### Proposed Revisions to a Standard Plans Index

Index Number: 455-002

Index Title: SQUARE PRESTRESSED CONCRETE PILE SPLICES

Sheet1: Updated language in notes and details for clarity.

INDEX 455-002	SHEET 1 of 1
------------------	-----------------

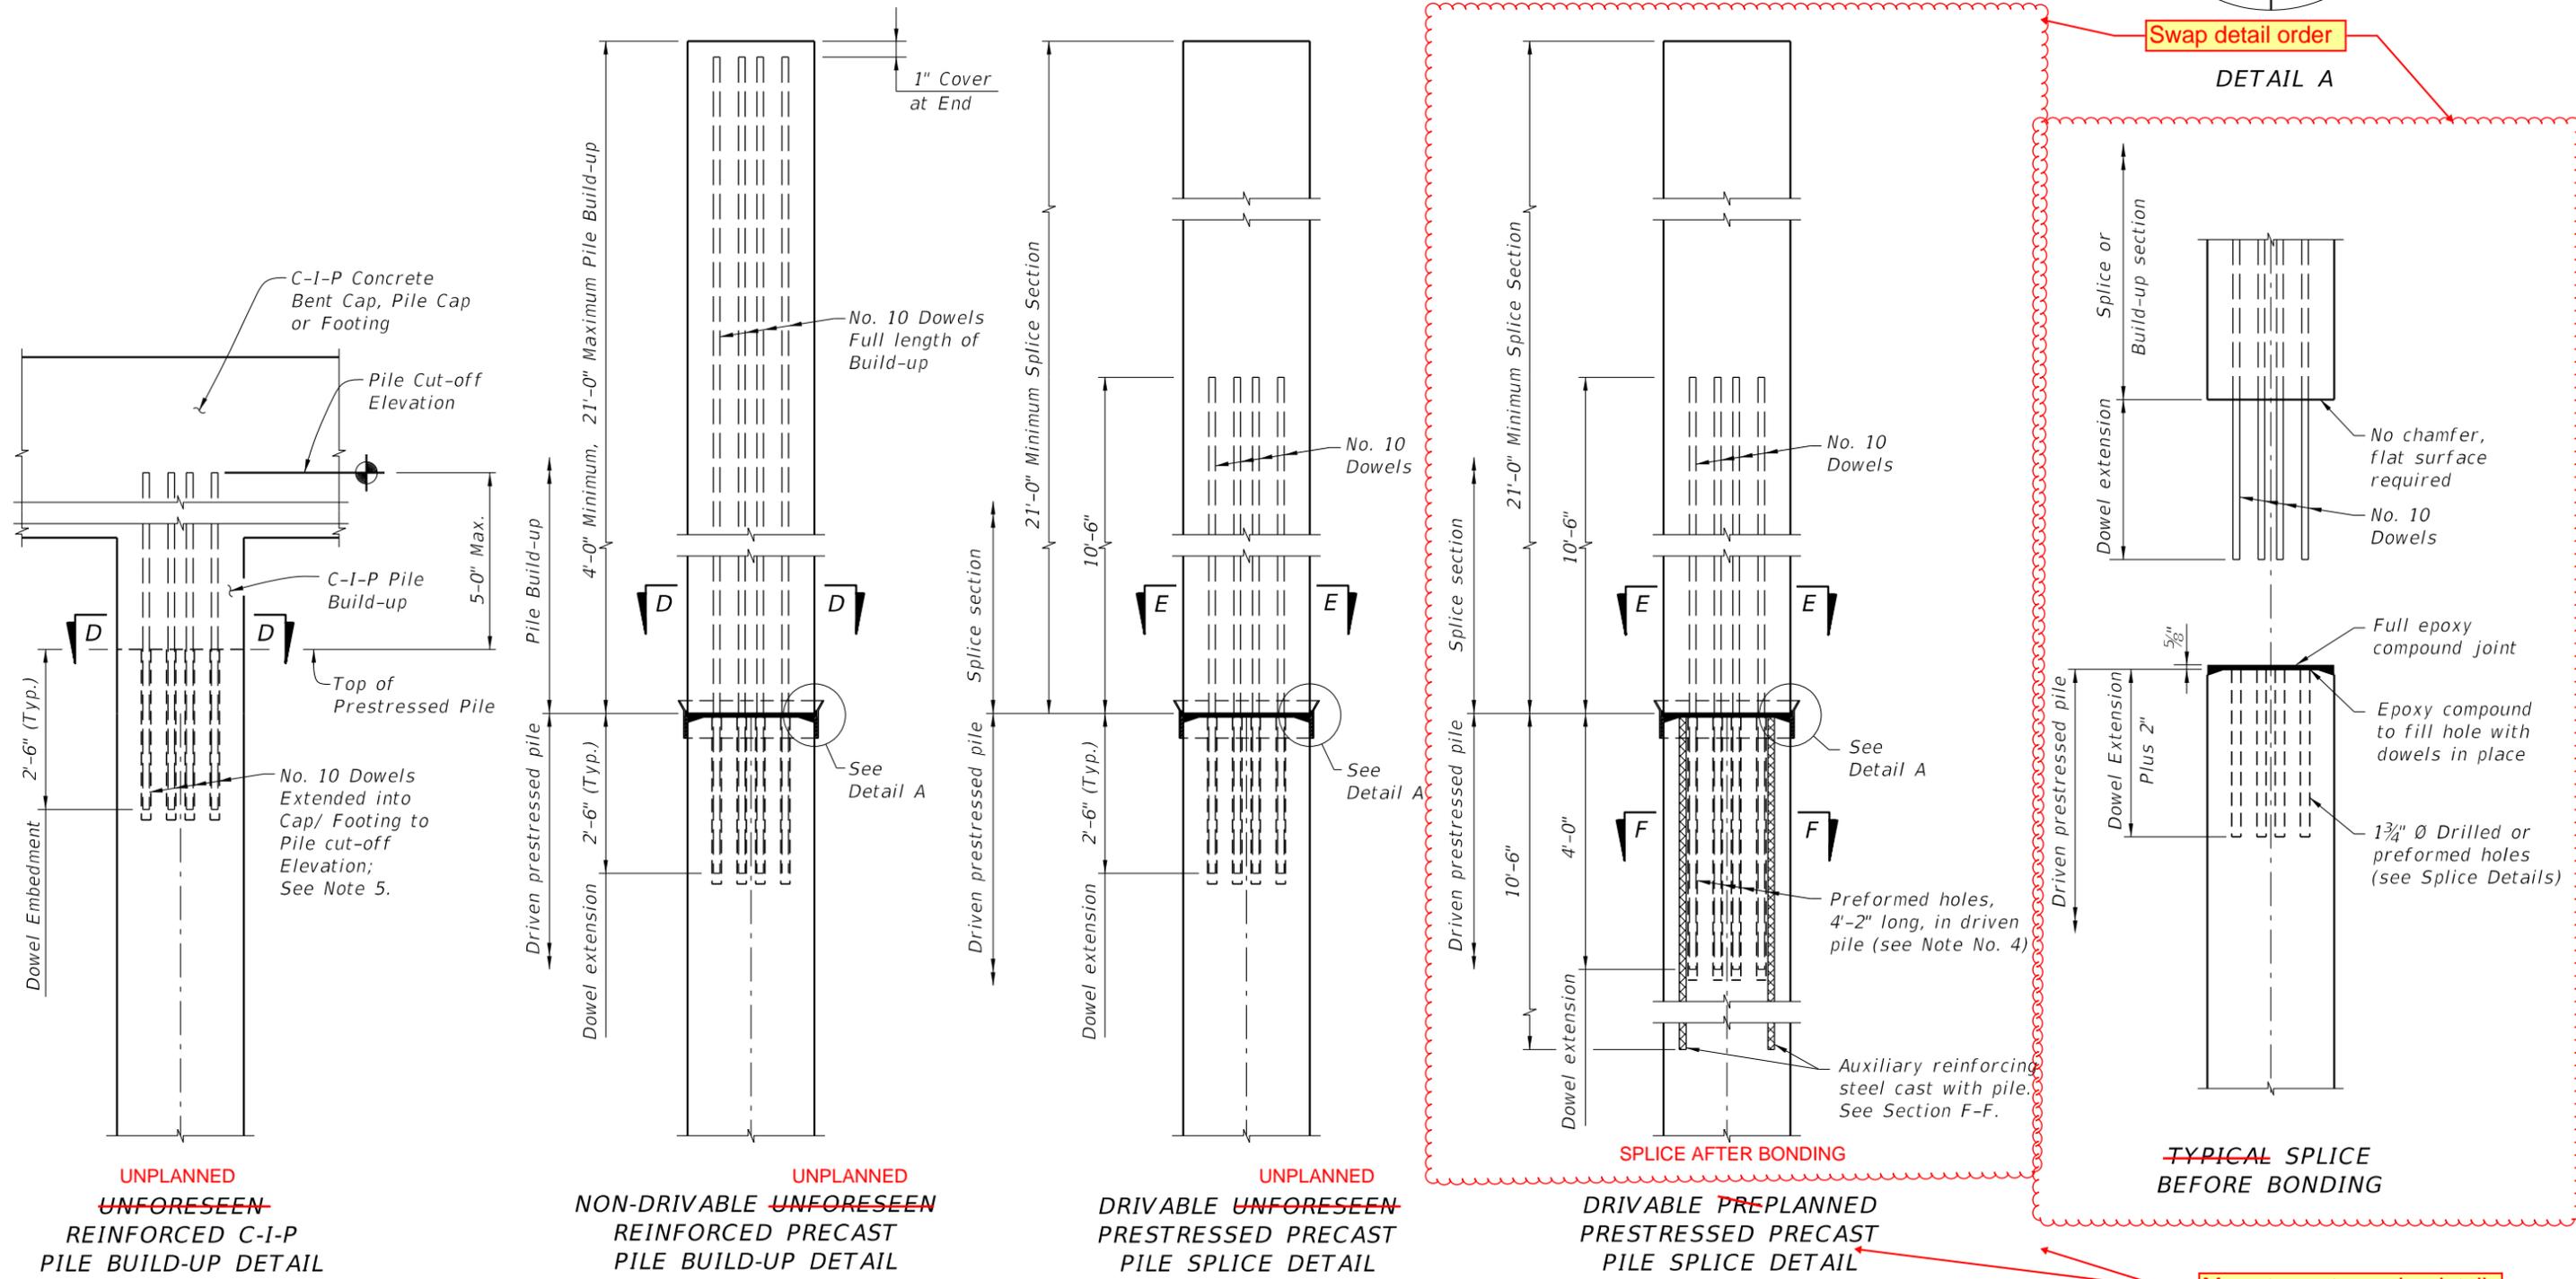
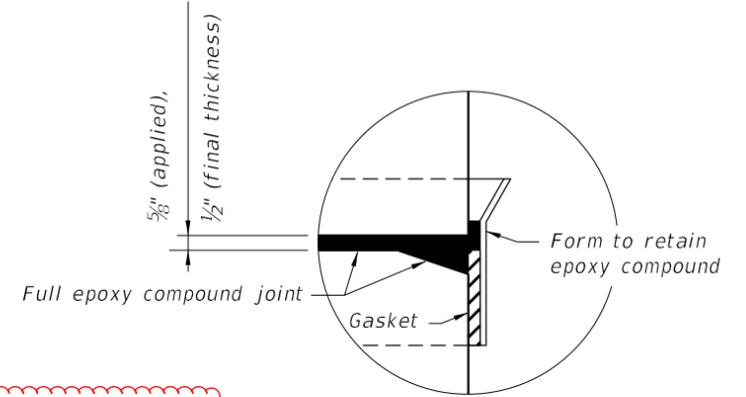
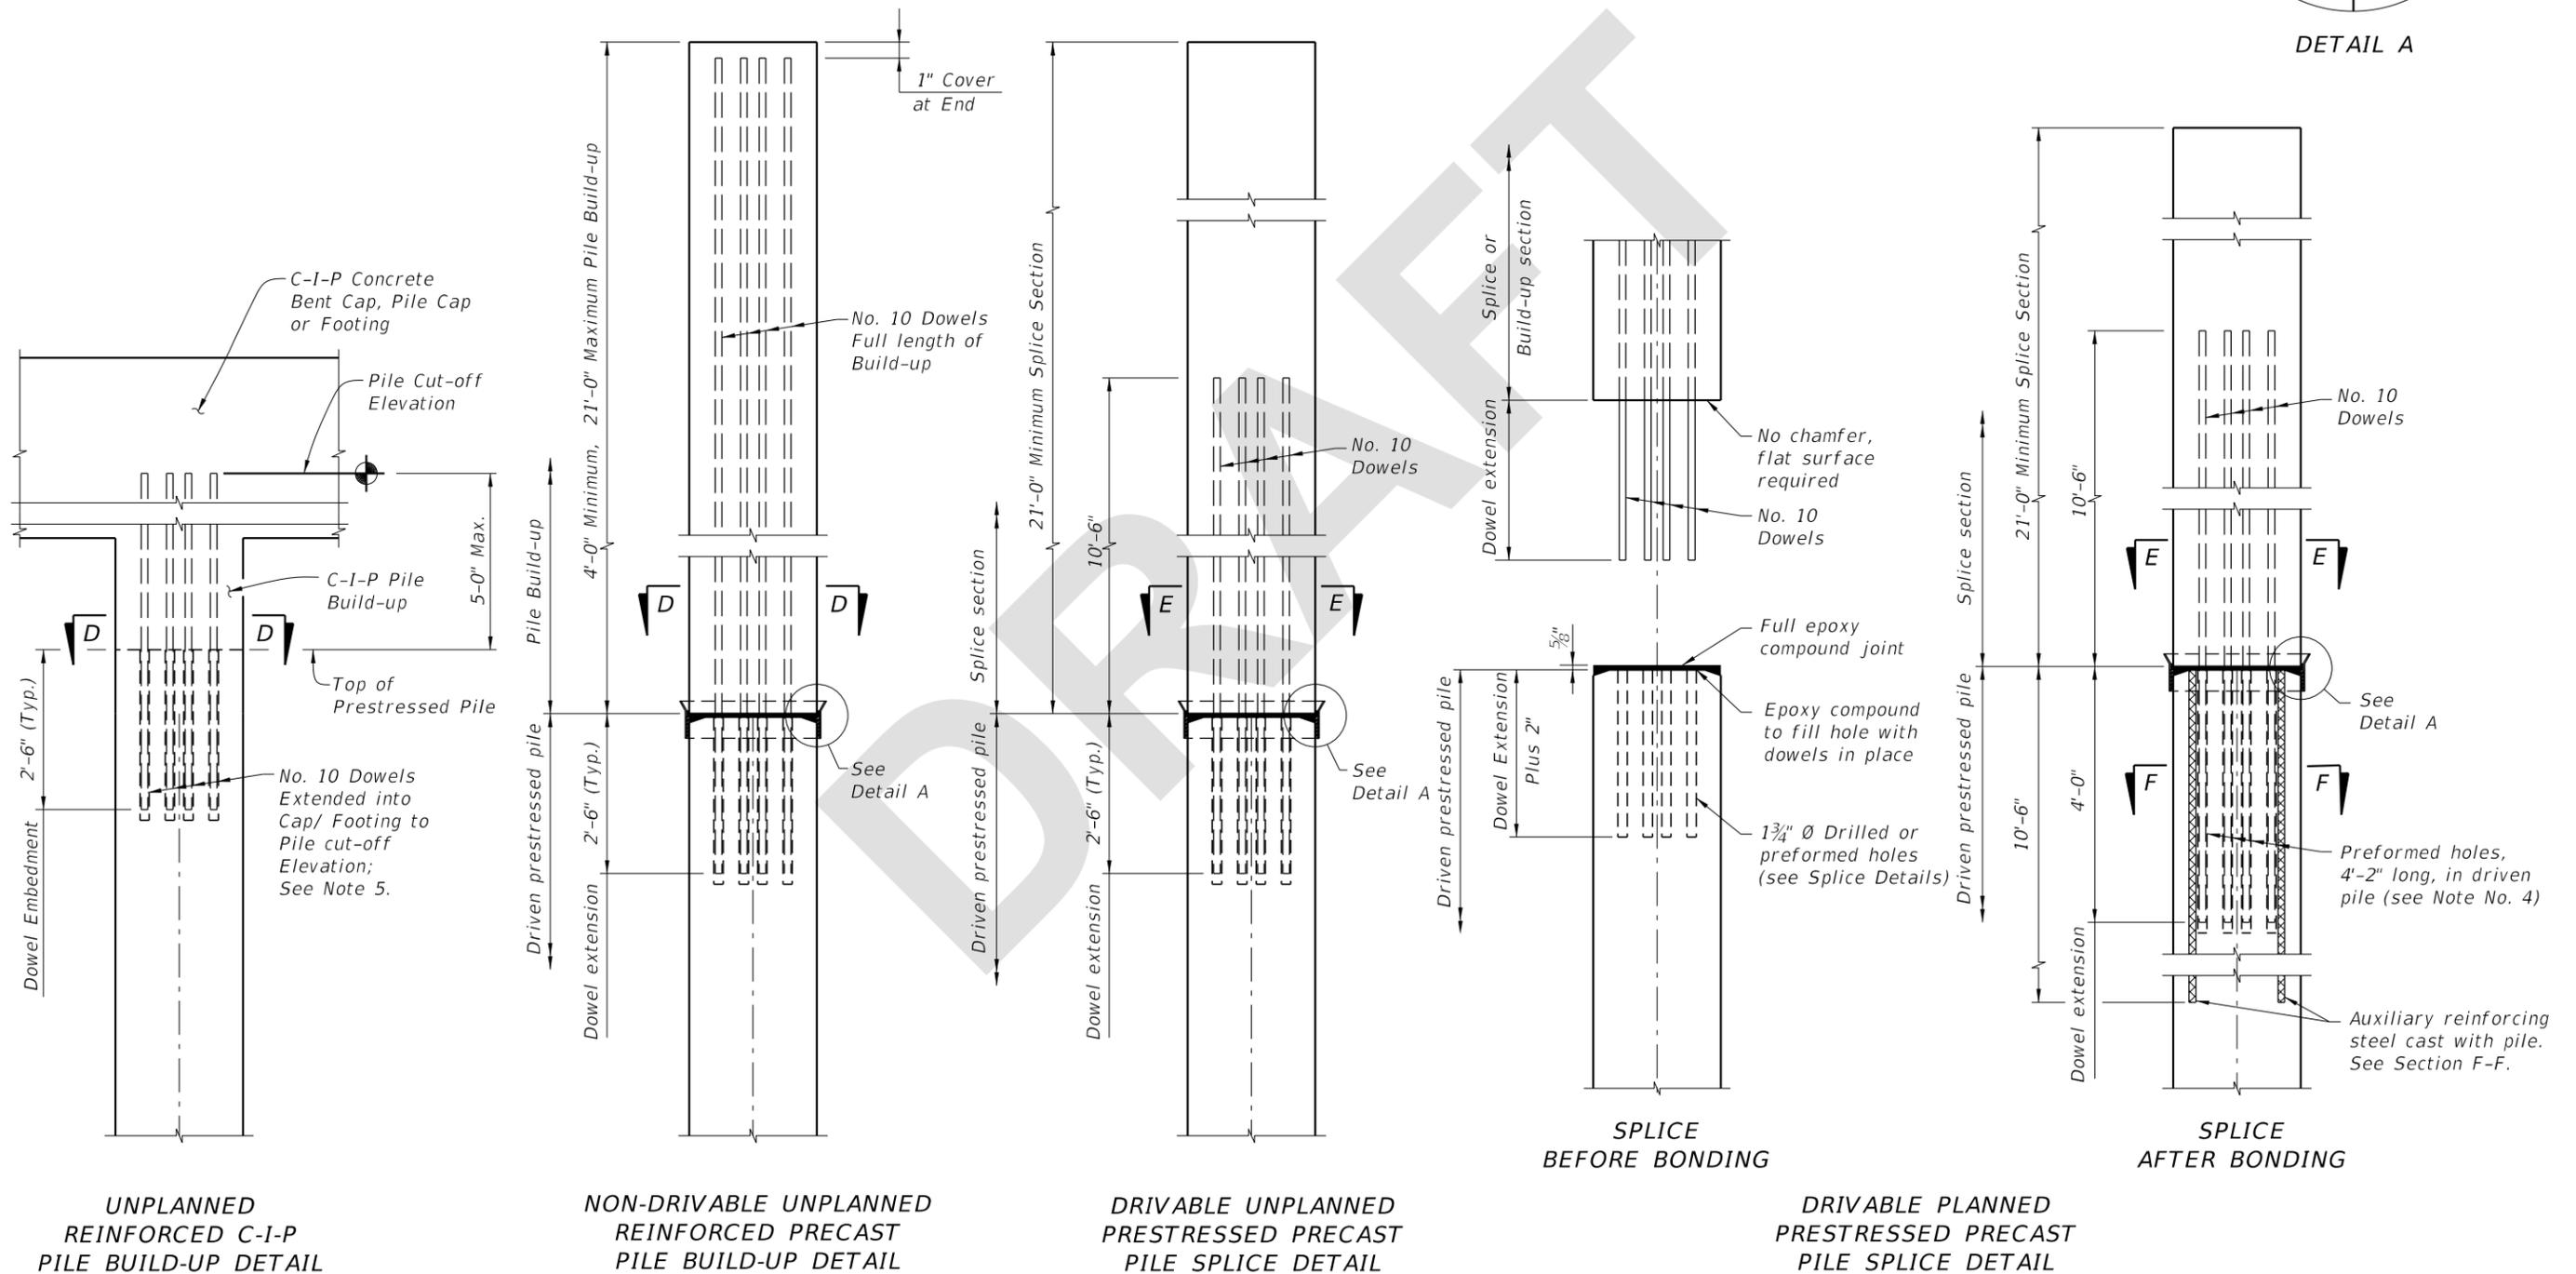
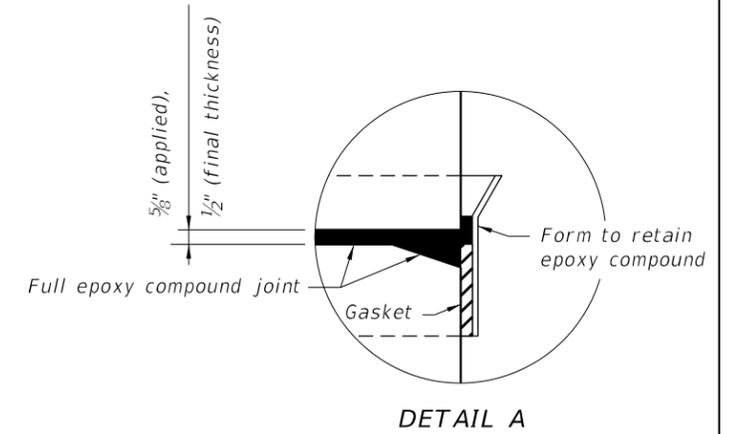
Andre made changes to the language to simplify and add clarity.

- ~~In cases where pile splices are desired due to length limitations in shipping and handling, the "Drivable Preplanned Prestressed Precast Splice Detail" shall be used.~~   
 ~~Mechanical Pile Splices contained on the Approved Products List (APL) may also be used.~~   
 *When necessary, limitations, use Planned or For preformed*

- When preformed dowel holes are utilized, the 1" spiral tie pitch shall be continued to 4'-0" below the head of the pile. See Index 455-018, 455-020 & 455-024. ~~Preformed holes shall utilize either removable preforming material or stay-in-place corrugated galvanized steel ducts. Stay-in-place ducts shall be fabricated from galvanized sheet steel meeting the requirements of ASTM A653, Coating Designation G90, 26 gauge. Ducts shall be 2" diameter, with a minimum corrugation (rib) height of 0.12 in. Ducts shall be fabricated with either welded or interlocked seams. Galvanizing of welded seams will not be required.~~   
 *use Specification is ducts*

Move to center under details

3. When pile splices are necessary due to shipping and handling limitations, use the "Drivable Planned Prestressed Precast Splice Detail" or Mechanical Pile Splices on the Approved Products List (APL).

4. When preformed dowel holes are used, continue the 1" spiral tie pitch to 4'-0" below the head of the pile, See Index 455-018, 455-020 & 455-024. For preformed holes; use either removable preforming material or stay-in-place corrugated galvanized steel ducts meeting ASTM Specification A653, Coating Designation G90, 26 gauge. Use 2" diameter ducts with a minimum corrugation (rib) height of 0.12 in. fabricated with either welded or interlocked seams. Galvanizing of welded seams is not required.
